Response to groundwater independent peer review

Our ref: 754-SYDGE206418-3-AP-Rev1

CGO Underground Development EIS - Addendum 1 of the hydrogeological assessment

Figure 1: Model mass balance error for the updated and original models

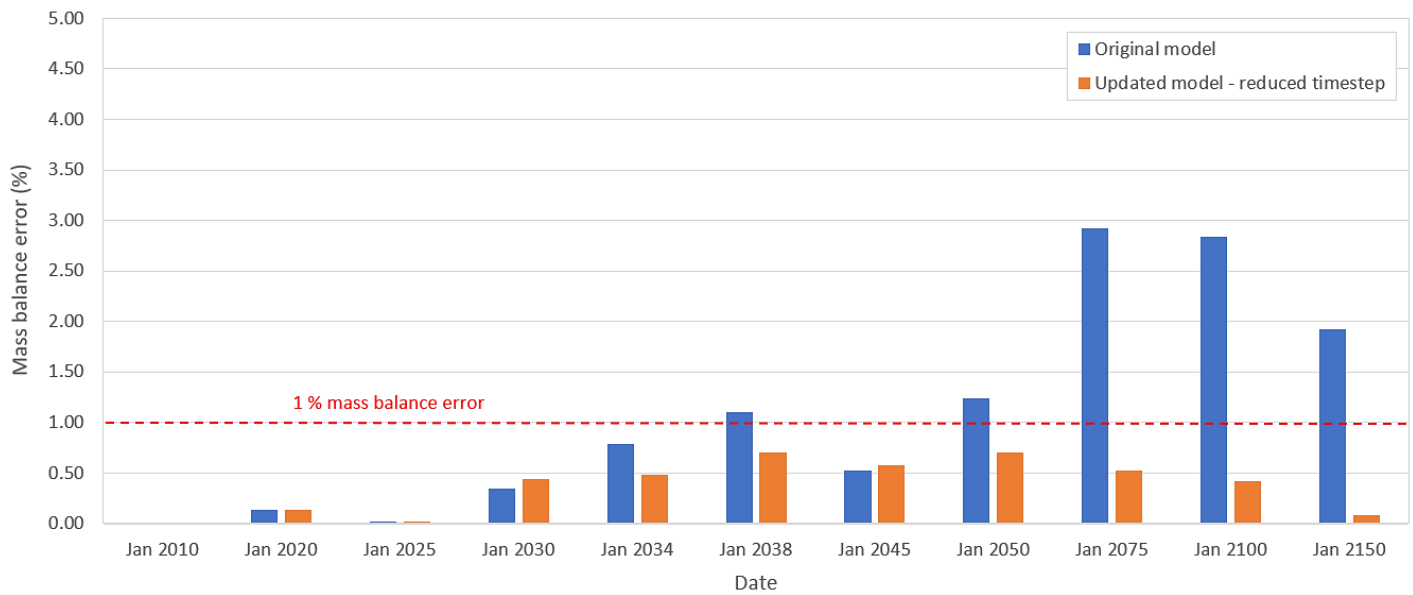
1. Provide documentation on the updated mine site model performance with an improved water balance error term (<1% for all times).

The numerical groundwater model was updated to have a reduced maximum time step, in order to reduce the model mass balance error. Figure 1 shows the resulting model mass balance error for the updated model. This can be seen to be below 1% throughout the model calibration (to 2020) and predictive periods. The original model mass balance error is also shown in the figure. Figure 2 shows the model time steps for the original and updated models.

Figure 5: Inflow / outflow at model boundaries and Lake Cowal nodes for the dry Lake Cowal case

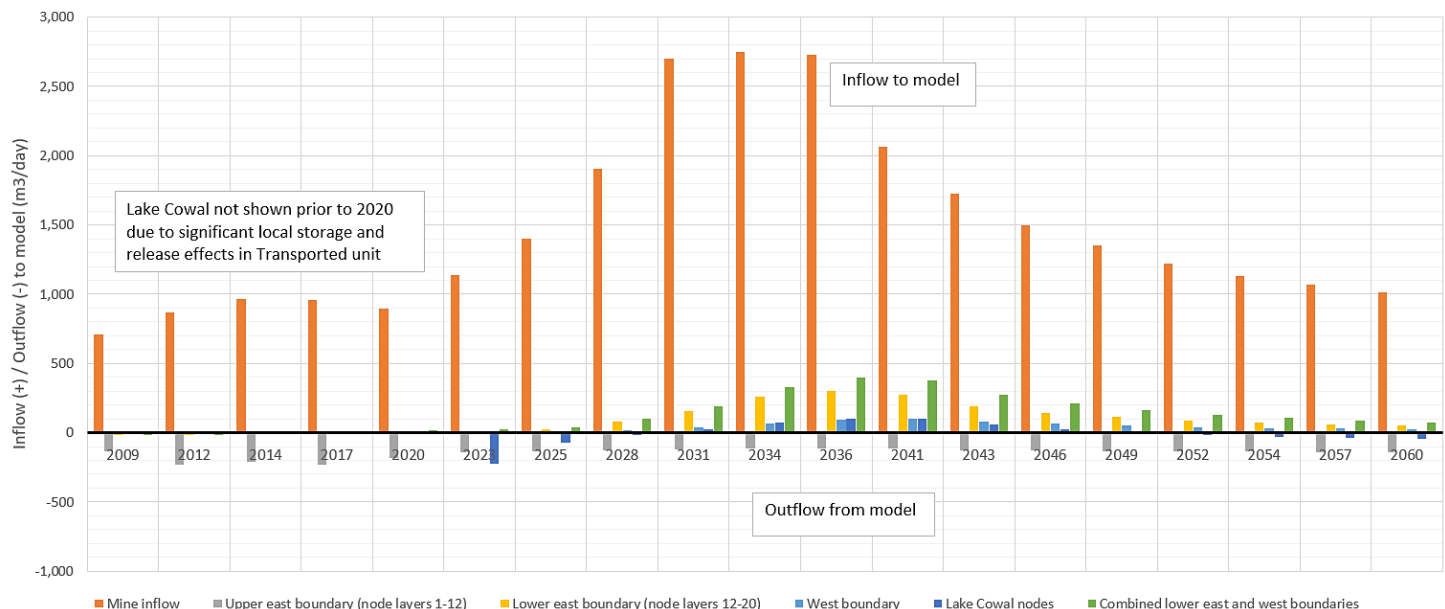
3. Provide more detail on the components of the water balance, notably components of discharge via dewatering bores, and via seepage faces at the pit walls and floor, and via horizontal drains, and leakage from the lake that is captured by the mine, including differences during lake full and empty periods.

Figure 5 and Figure 6 present inflows into the model from the fixed head western and eastern boundaries, and from the Lake Cowal time varying fixed head nodes, excluding rainfall recharge. These figures show the dry Lake Cowal and full Lake Cowal cases respectively. The results divide the eastern boundary into an upper and lower level. This was done to separate localised outflow at the top of the eastern model boundary which occurs due to the interaction of the Lake Cowal fixed head nodes and the eastern boundary fixed head nodes. This flow to the east from the eastern part of Lake Cowal has a negligible impact on inflows to the mine site. This can be seen more clearly in Figure 7, which shows the typical groundwater head contours along a west to east section through the mine in 2024.

Figure 5 shows a small amount of flow into the model from the Lake Cowal nodes for a dry Lake Cowal case. This is a result of a fixed head boundary condition of 201.5 mAHD being applied to these nodes for the dry Lake Cowal case. The rate of inflow to the model from the Lake Cowal nodes is under 5% of the total inflow to the mine and is not considered to affect the predicted inflow to the mine.

Figure 11: Pit dewatering records, rainfall and modelled groundwater inflow to the open pit (mine site report Figure 8-18)

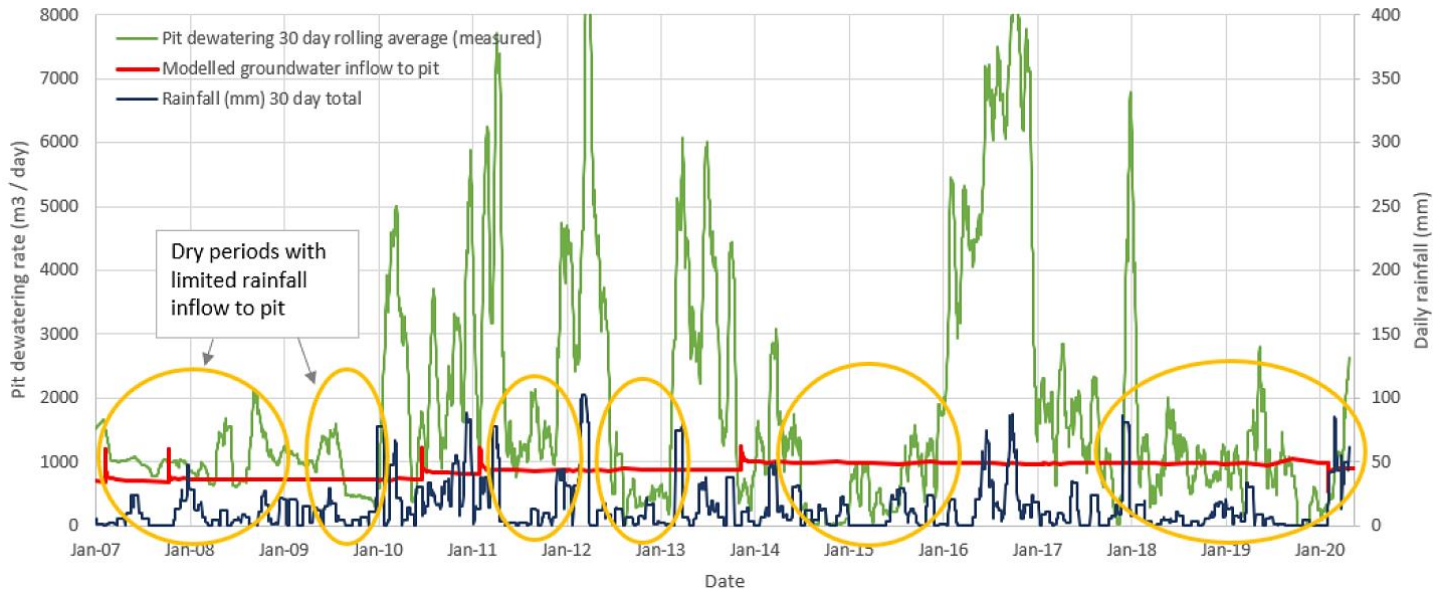
4. **If still relevant given the above, provide improved justification of the very steady mine inflow rate predictions compared to the high variability in reported inflows, and why it is acceptable for the model to be benchmarked to 'groundwater inflows' only during dry periods.**

Modelled groundwater inflow rates are much less variable than recorded pit dewatering volumes, as shown in Figure 11 below. The spikes in recorded pit dewatering volumes are likely related to surface water runoff into the open pit and not groundwater inflow. This is due to groundwater flow being proportional to gradients in groundwater head. These do not suddenly change by factors of 5 over the space of a month, which recorded pit dewatering volumes sometimes do. Surface water runoff is removed from the pit relatively quickly, and it is not considered to significantly affect groundwater levels in the area around the open pit, and so has been excluded from the groundwater model.

It is considered that during drier periods, such as 2018, recorded pit dewatering rates are more representative of actual groundwater inflows rather than surface water inflows. For this reason, it is considered acceptable to use such periods as a basis for comparison, or benchmarking, of modelled versus observed groundwater inflow to the open pit.

Figure 12: Sensitivity to paste backfill porosity of predicted inflow to open pit, stopes, access tunnels and post-mining infiltration

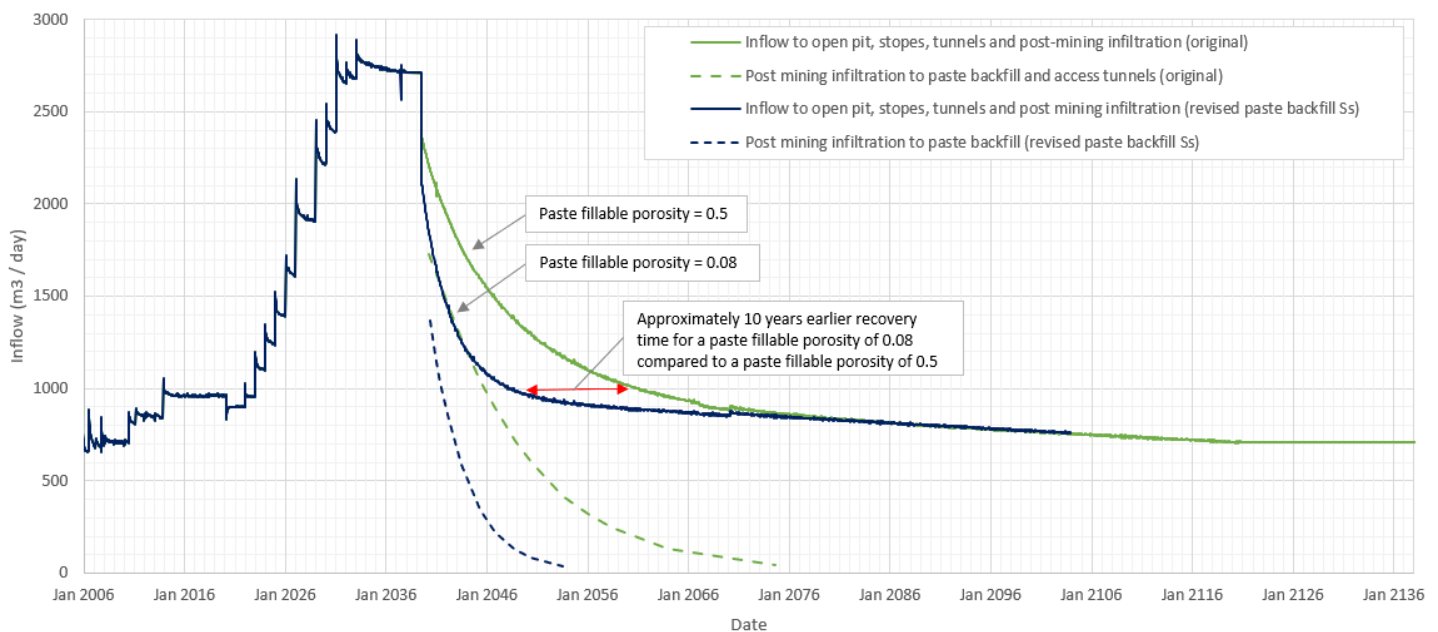
6. Provide updated post-mining simulations with corrected paste backfill Ss parameters, along with related final void water balance modelling, including confirmation that the recovery simulation started from the base of the underground dewatered stopes at around -700 mAHD.

Figure 12 presents the predicted total inflow into the open pit, stopes, access tunnels and paste backfill for the two cases of paste fillable porosity of 0.08 and 0.5. It can be seen from the figure that the recovery time for a paste fillable porosity of 0.08 is approximately 10 years earlier compared to that for a paste fillable porosity of 0.5.

Figure 17: BCPB model calibration sensitivity to hydraulic conductivity parameters (after BCPB report, Figure 6-6)

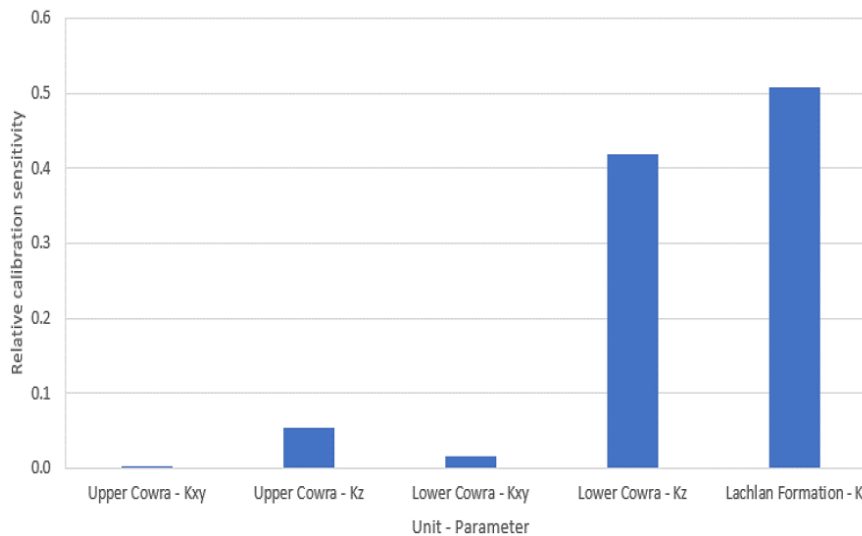
7. Provide a rationalisation of the inconsistencies between the mine site and the borefields models in relation to the Upper Cowra unit having a more limited westwards extent over the CGO site area in the borefields model, and it having quite different values for its key properties (K_h and S_y).

It is considered that, due to its low calibration sensitivity in the BCPB model, the calibrated horizontal hydraulic conductivity of the Upper Cowra unit in the BCPB model is not applicable to the mine site area. The BCPB model, developed to assess groundwater impacts from drawdowns in the Bland Creek Palaeochannel, did not account for mining activities and monitoring at the mine site and this has led to the difference in the assessment of parameters between the two models. The BCPB model was calibrated to provide assessment of conditions within the high yielding aquifers of the Bland Creek Palaeochannel while the Mine Site Model was calibrated against the observations in the low yielding ground around the mine site.

Figure 21: Cumulative groundwater table drawdown in 2040 from the mine site and BCPB models

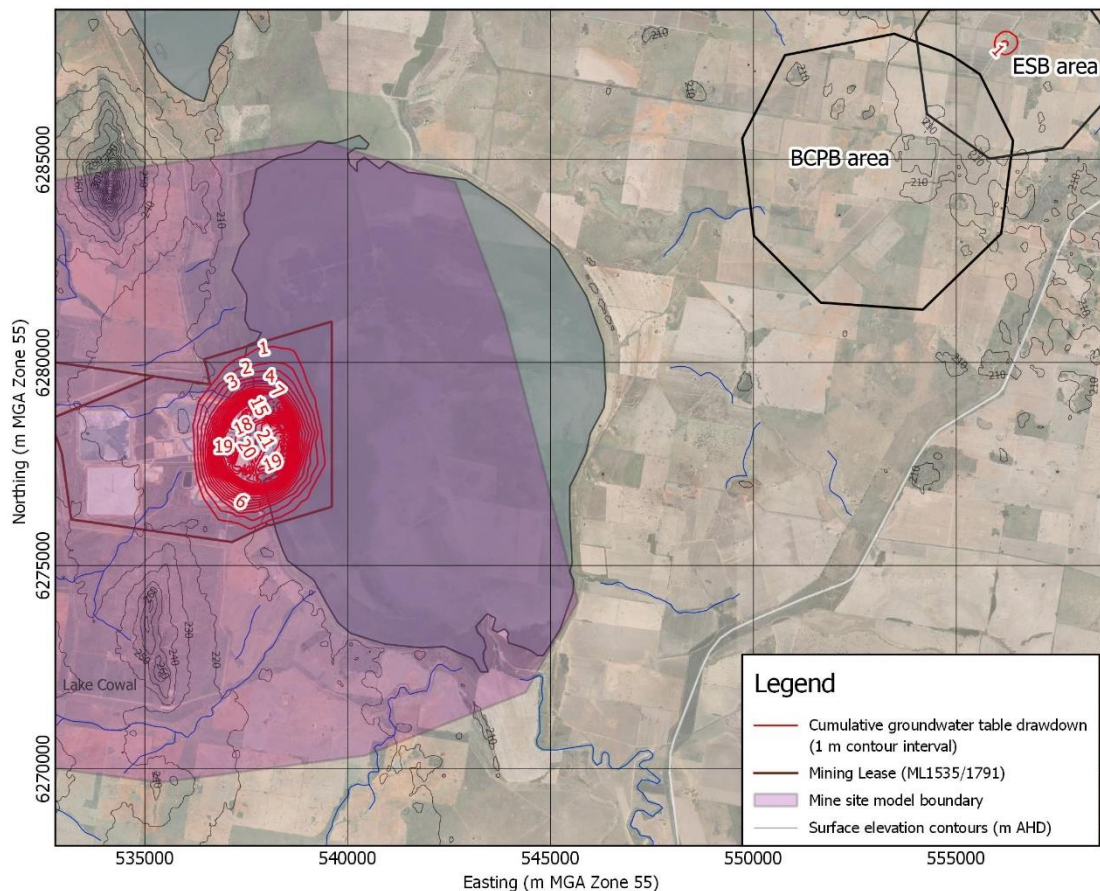
8. Provide an objective assessment of the magnitude and extent of cumulative drawdown impacts (mining and borefields, possibly using the principle of superposition), noting that the DPIE reviewer does not believe that the effort required for an integrated modelling of cumulative impacts is commensurate with the groundwater-related risks and uncertainties predicted for the proposed underground development, despite low confidence in the mine site model results.

Figure 21 presents the combined groundwater table drawdowns from the mine site model and the BCPB model using the principal of superposition. It can be seen that there are no significant cumulative effects on the groundwater table.

Figure 22: Predicted Final Void Water Quality (Salinity TDS mg/L) (after Gilbert & Associates, 2008)

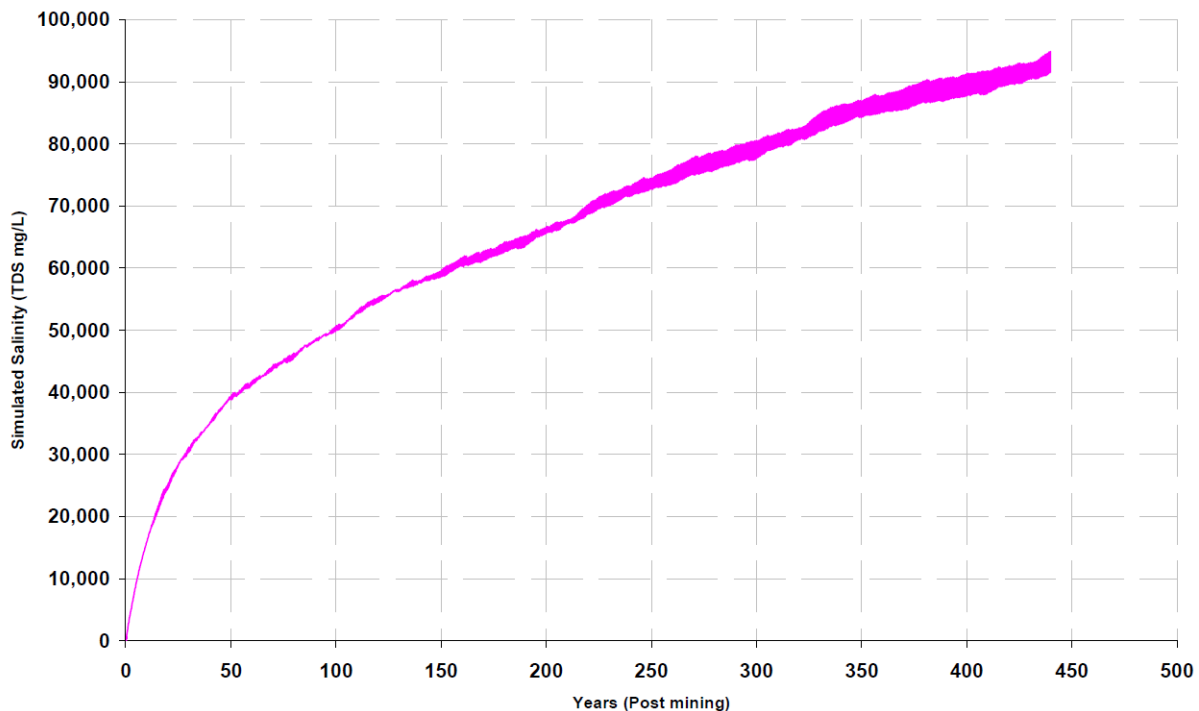
9. **If the previous assessment information on the final void lake water quality (Gilbert and Sutherland, 1997) is considered not adequate in relation to the current proposal, then detailed information is required on the long term prediction of final void lake hydro-geochemistry, including the influence of the backfilled underground voids, with comprehensive justification on the sustainability of the rehabilitation plan;**

A previous hydrogeological assessment (Cowal Gold Mine E42 Modification - Hydrological Assessment, Gilbert & Associates Pty. Ltd ref: J0616-1.rg1b.doc, dated: July 2008) (the Gilbert & Associates report) provides discussion on the final void lake water quality. This is considered adequate in relation to the current proposal, which does not propose changes to the final open pit void shape from the previous approval (Mod 14). The presence of stopes paste backfill from the proposed underground development is not expected to significantly affect the chemistry of the groundwater flowing into the open pit post mining.

The void water quality would reflect the influence of the high salinity in the groundwater. Predictions of average void salinity based on a solute balance between inflows and outflows confirm that salt concentrations in void waters would slowly increase. However, the lower groundwater inflow rates mean that salinity would increase more slowly than was originally predicted for the approved CGM – reaching about 67,000 mg/L after about 200 years – refer Figure B-6. Salinity is predicted to continue to increase trending to hyper-salinity.
